Update: SIB 61 07 24 Recall 24V-557: Replace Starter Relay

SIB 61 07 24 RECALL 24V-557 Replace Starter Relay

Model	Model Description	Model Code
KA1	R 1300 GS	0M23

**6****▶ Removing semiconductor starter relay**

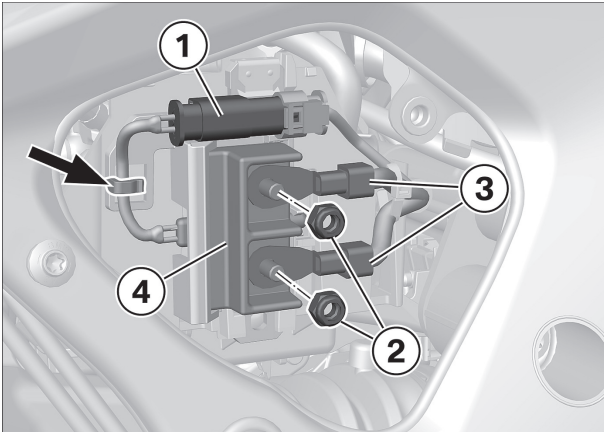
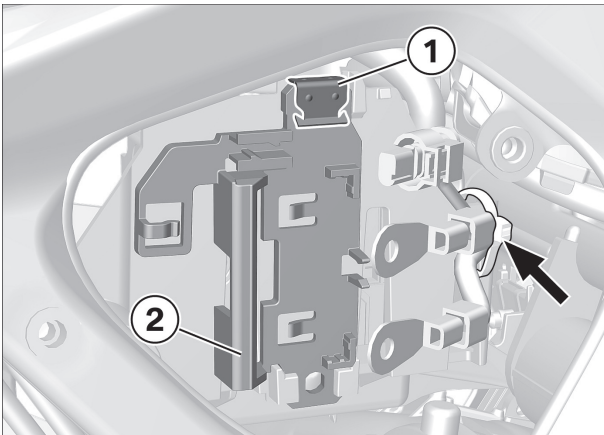
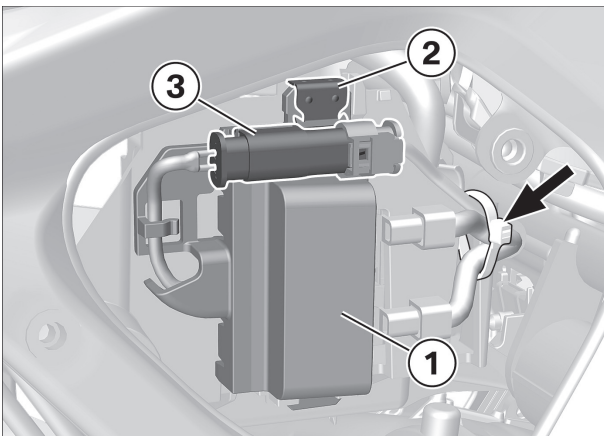
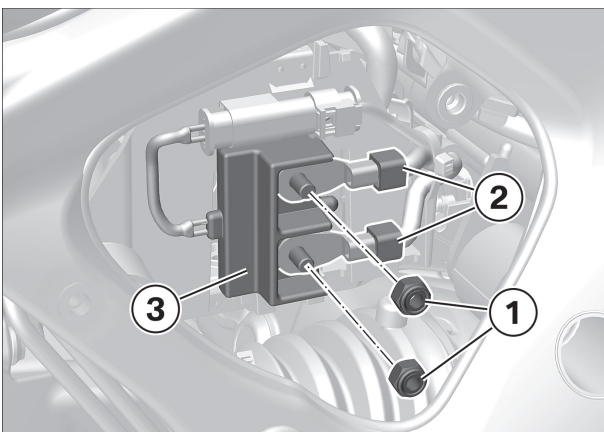
- There are two build levels of the semiconductor starter relay:
 - Starter motor relay with holder
 - Starter motor relay with cover cap
- Select the respective repair method according to the build level.

- Disconnect connector **(1)** and detach cable **(arrow)**.
- Remove nuts **(2)**.
- Loosen cable shoes **(3)**.
- Loosen starter motor relay **(4)** from holder and thread out connector **(1)**.

- Remove cable strap **(arrow)**.
- Disconnect connector **(3)**.
- Remove clamp **(2)** and remove retaining cap **(1)**.

- Remove nuts **(1)**.
- Loosen cable shoes **(2)**.
- Remove starter motor relay **(3)**.

► **Installing electromagnetic starter relay**

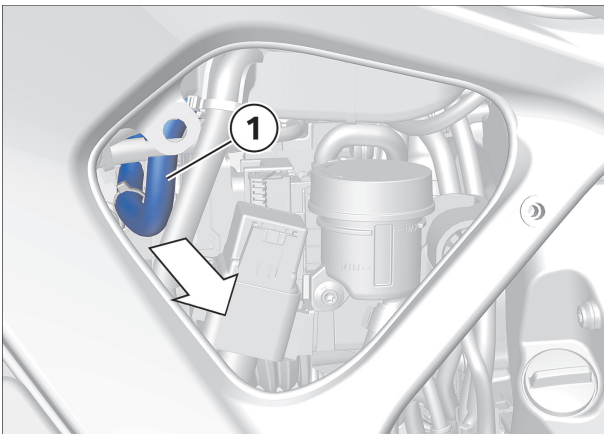
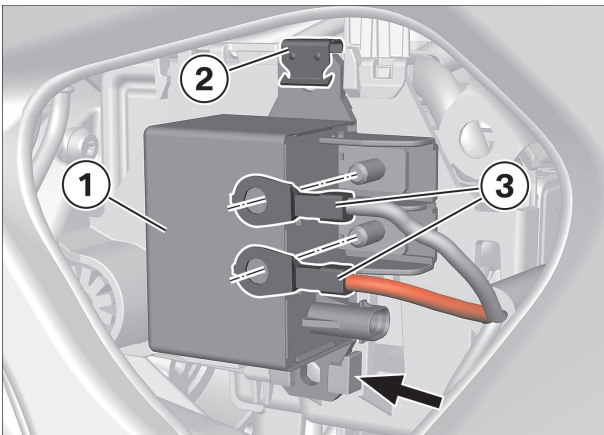
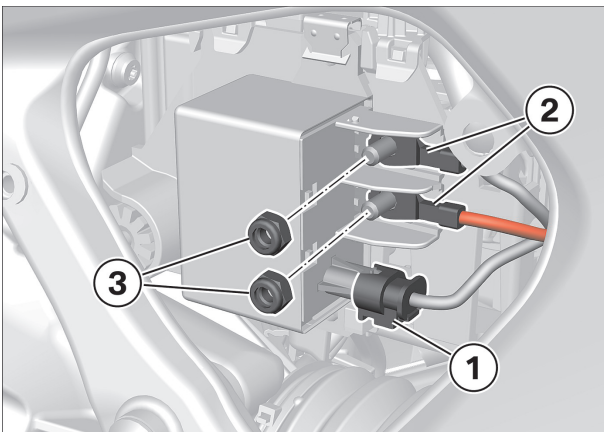
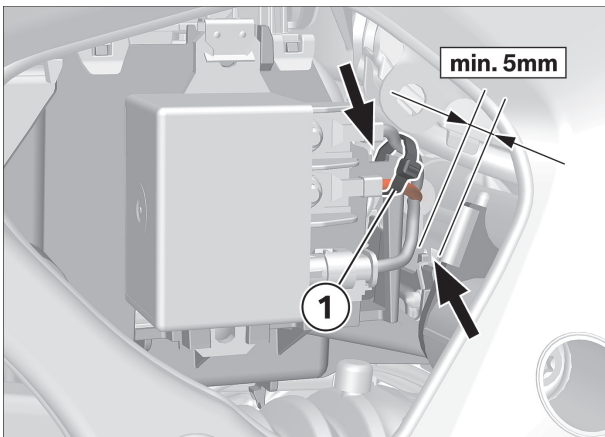
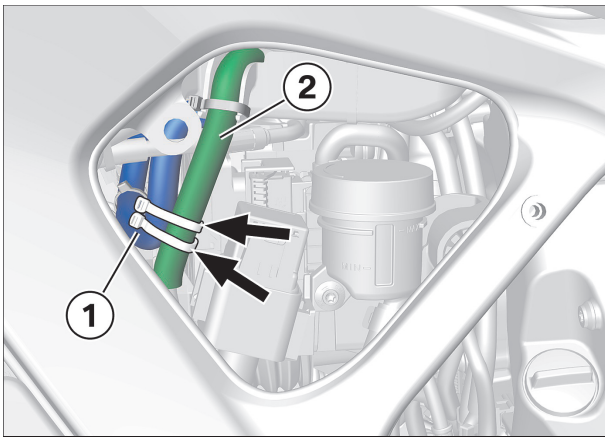
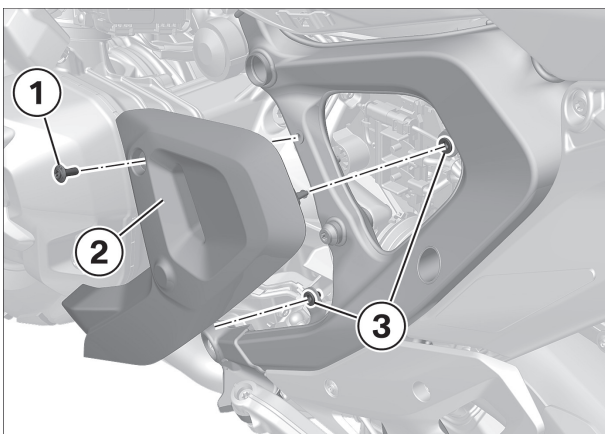
- Ensure sufficient distance to frame and body parts.
- Route wiring harness accordingly and fasten it in place with cable straps.

- Position the starter motor relay **(1)** in the bracket **(arrow)**.

- Install retaining clip **(2)**.
- Align cable shoe **(3)** on stud.

- Connect connector **(1)**.
- Secure cable shoes **(2)** with nuts **(3)**.

Tightening torques		
Wiring harness to starter relay		
M6, Renew nut	5 Nm	
Thread-locking compound (mechanical)

- Install cable strap (1) but do **not tighten** it yet.
Only secure the upper cables on the equipment holder.
- Make sure that the wiring harness is not in contact with the frame eyelet or frame plate (**arrows**).

- Tighten cable straps (1).
- **If the minimum distance is not reached:** Create TSARA case and follow the instructions.

- Secure wiring harness (1) with **two** cable straps (**arrows**) on wiring harness (2).
Install the lower cable strap as close as possible to the cable bend to prevent the cable from springing back.
